**NSLPP MEETING HELD ON 06/04/22****Attachments:**

**ADDRESS/WARD:** 64 Rangers Road, Cremorne**APPLICATION No:** DA 368/2021**PROPOSAL:** Construction of a studio and alterations to existing semi-detached dwelling.**PLANS REF:**

**APPLICANT:** Council Approval Group**AUTHOR:** Report of Thomas Holman, Assessment Officer**DATE OF REPORT:** 28 February 2022**DATE LODGED:** 04 November 2021**RECOMMENDATION:** Approval

Figure 3 – West, East & North Elevation (Dwg 2 dated 14 October 2021)

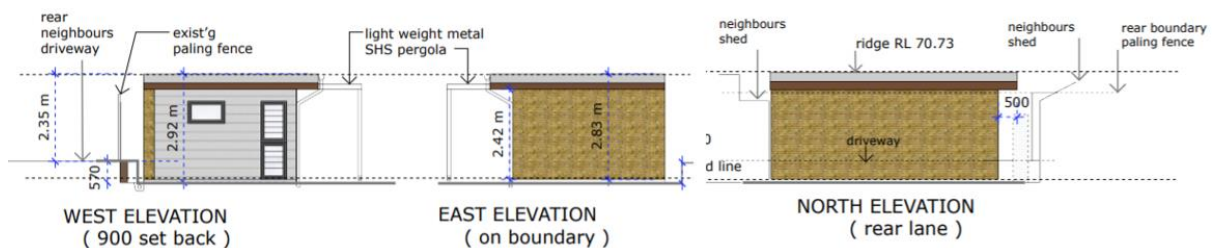
The proposed detached studio has a maximum height of 2.92m as shown in figure 3 of this report therefore the studio complies with the permissible height limit of 8.5m in accordance with clause 4.3 in NSLEP 2013.

Figure 5 – Front Elevation - Dwg No 3 dated 14 October 2021

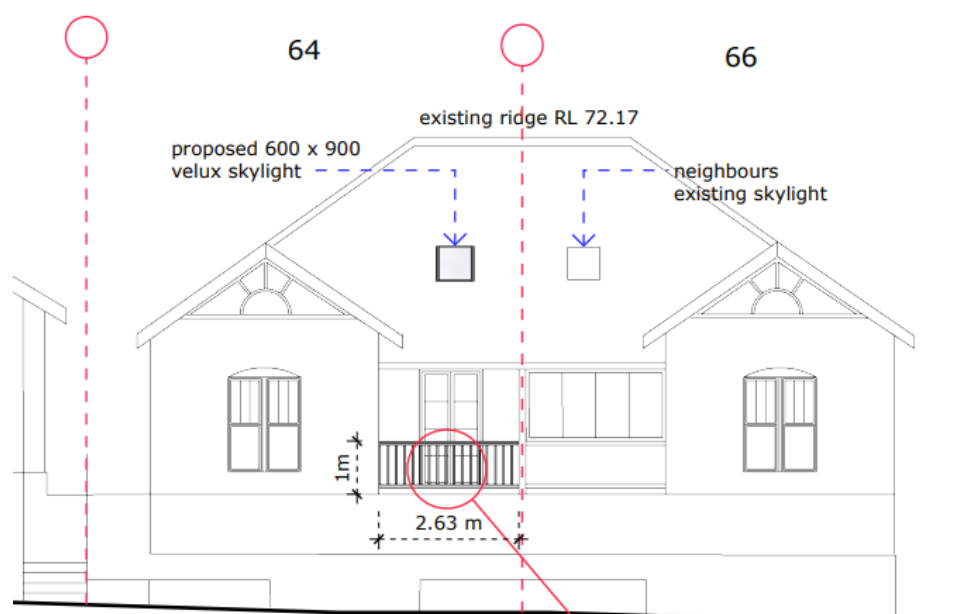
*The skylight on the front roof plane is not supported and does not comply with Part B Section 13.9.1 of NSDCP 2013. It is recommended that this skylight be deleted. The existence of the skylight next door does not set a precedent for this proposed skylight.*

Council's Conservation Planner does not support the provision of a skylight on the front roof plane given that it is an uncharacteristic element of the Cremorne Conservation Area as stipulated in Part C, Section 6.3 of the NSDCP 2013 so a condition of consent is recommended deleting the skylight on the front elevation.

Part of the proposed works include the provision of a skylight to the front roof slope facing Rangers Road. The skylight is not supported by Council's Heritage Officer being an uncharacteristic element within the conservation area. It is therefore recommended as part of a condition of consent that this element is not approved and should be deleted from the consented works (C6 Delete Skylight).

The skylight located on the front roof slope would be highly visible from Rangers Road is also an uncharacteristic element within the Cremorne Conservation Area therefore a condition of consent will require its deletion from the scope of approved works (C# Delete Skylight).

- C6. The proposed skylight is not approved and is to be deleted from the front southern roof plane. The skylight that is not approved is clouded in red on the approved South Elevation (Dwg No. 3 dated 14 October 2021).

Figure 8 – Annotated Site Plan - Dwg No. 1 (left) and Annotated Survey Plan – Dwg No. 33484-04 (right)

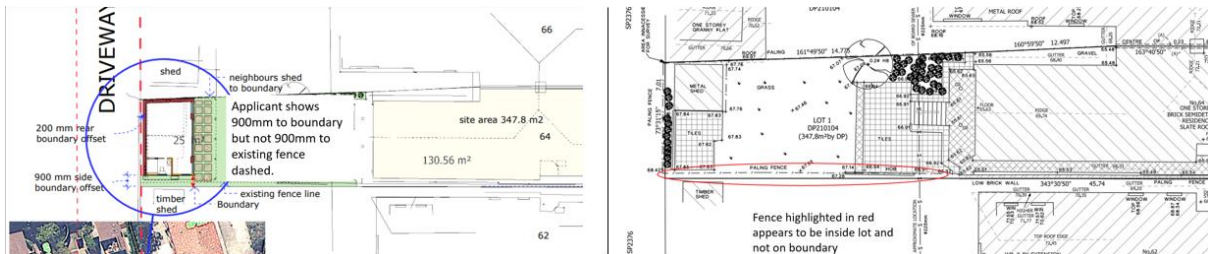
It is understood that there is a boundary dispute between the subject site and 62 Rangers Road with a boundary fence not located on the boundary but within the land of the subject site as shown in the Site Plan and Survey Plan prepared by Frank M Mason & Co. Pty Ltd. For the purposes of determining setbacks to the western boundary the applicant is relying on the Survey Plan prepared by Frank M Mason & Co. Pty Ltd.

Figure 19 – Proposed Compliance Diagram dated 18 November 2021

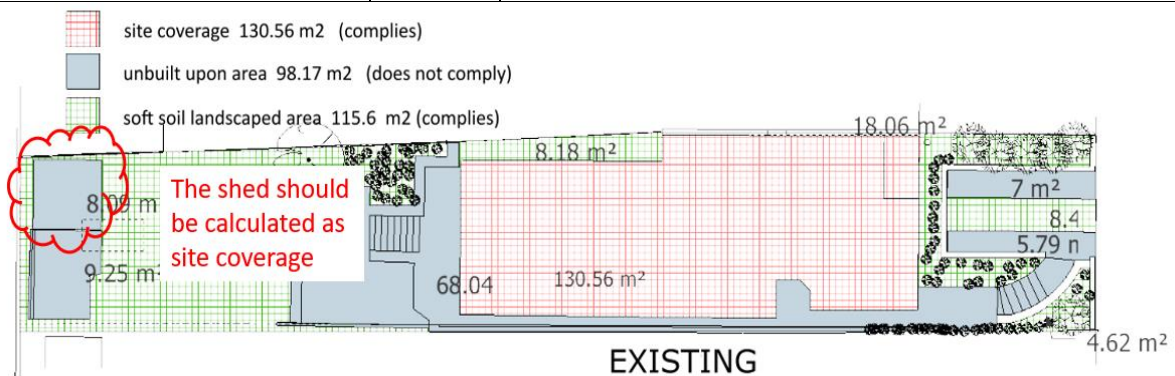
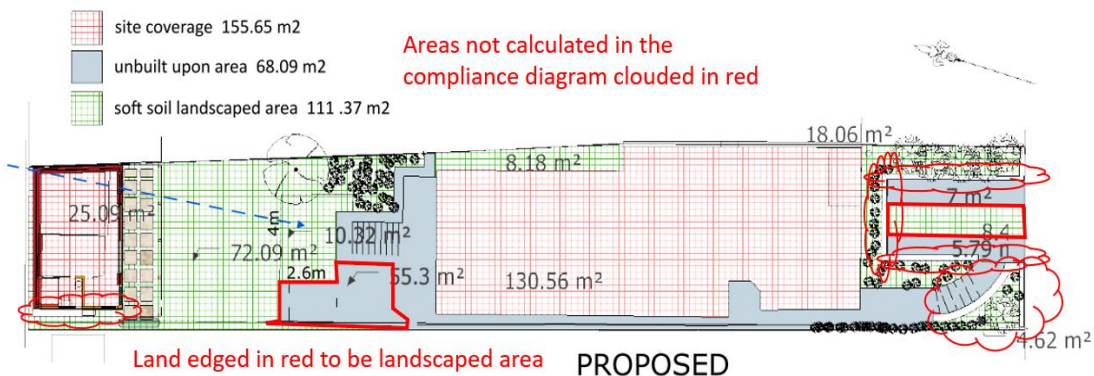
<b>1.5.6 Landscape Area</b>	Yes	<p>The proposed landscaped area and un-built upon areas do not comply with the minimum 30% landscaping requirement and maximum 20% un-built upon area as stipulated in Table B-1.7 of the NSDCP 2013.</p> <p>As per the below annotated plans there are inaccuracies in the compliance diagram with retaining walls in the front garden (12.69m<sup>2</sup>) not calculated as un-built upon area and an area between the tyre strips (8.4m<sup>2</sup>) in the front driveway incorrectly considered as landscaped area. A condition of consent is recommended (C#### Landscape Plan) requiring additional landscaping to ensure compliance is achieved for both landscaped area and un-built upon area as annotated below.</p> <p>Compliance with both landscaped area and un-built upon areas is required to ensure the site provides a landscaped buffer between adjoining properties, generally promotes landscaping including tree planting and maximises the retention of and absorption of stormwater on the site therefore complying with the applicable objectives contained in s1.5.6 of the NSDCP 2013.</p>

An assessment of the existing and proposed compliance diagrams confirms there are minor miscalculations but these have been addressed in the assessment report and a condition will ensure additional landscaping is provided (C18 Landscape Plan).

- Planting of 1 local native canopy tree with a minimum mature height of 6m (pot size 75l) within the rear garden of the subject site.
- Removal of pavers and pebbles within driveway between paved tyre strips to be replaced with groundcovers/grasses.
- The existing pavers and pebbles within the driveway between the paved tyre strips may remain if the Landscape Plan sufficiently ensures the provision of a minimum 30% (104.34m<sup>2</sup>) landscaped area within the site as defined in Provision P2, s1.5.6 of the North Sydney Development Control Plan 2013.
- Removal of pavers within rear garden to be replaced with groundcovers/shrubs or grasses (area to become soft landscaping annotated on Compliance Diagram).
- The gravel area (annotated in red on the Compliance Diagram) within the eastern side setback is to be replaced with either groundcovers/shrubs or grasses.

**Figure 22 – Approved Driveway under DA 358/07/2 and photo of existing driveway (North Sydney Council, February 2022)**

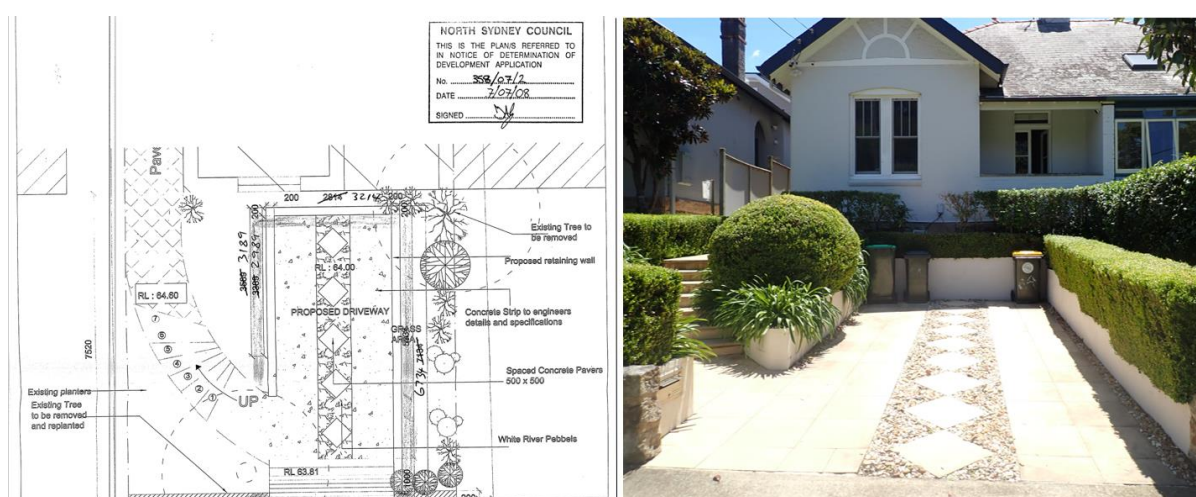
- ***Soft landscaping is identified in the driveway between the trye strips, however, the area is tiled not inclusive of landscaping.***

The driveway with diamond shaped tiles and pebbles in between the tiles and concrete driveway strips was approved under DA 358/07 and a subsequent modification DA 358/07/2 as per the approved plan below. The area between the concrete trye strips is not landscaping pursuant to the definition in Provision P2, s1.5.6 of the NSDCP 2013. Landscaped area is defined as all parts of a site used for growing plants, grasses and trees but does not include any hard paved area. The subject site proposed landscaped area marginally complies with the minimum landscaped area of 30% stipulated in Table B-1.7, s1.5.6 of the NSDCP 2013 when accounting for the landscaping between the trye strips. A condition of consent will require the area between the driveway strips to be soft landscaping comprising of grasses/groundcovers (C#### Landscape Plan) or 30% landscaped area to be achieved within the site without alterations to the pavers/pebbles between the existing driveway strips.

Figure 23 – Annotated West Elevation (Dwg 2 of 3) dated 14 October 2021

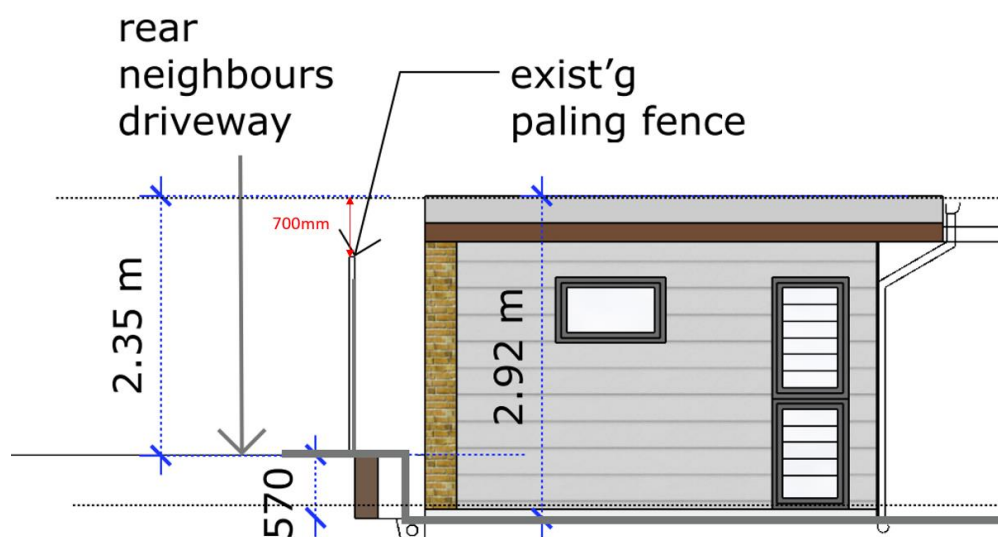
- **The construction of a Granny Flat in close proximity to the rear boundary fence is detrimental to the appearance of the driveway serving 13 Cranbrook Avenue.**

The detached studio will have a 200mm setback to the rear boundary fence. Approximately 700mm of the studio would be visible from the adjoining driveway as per the below annotated plan. The majority of the studio would be obscured behind the rear fence not obtrusive or dominant in context with the driveway.
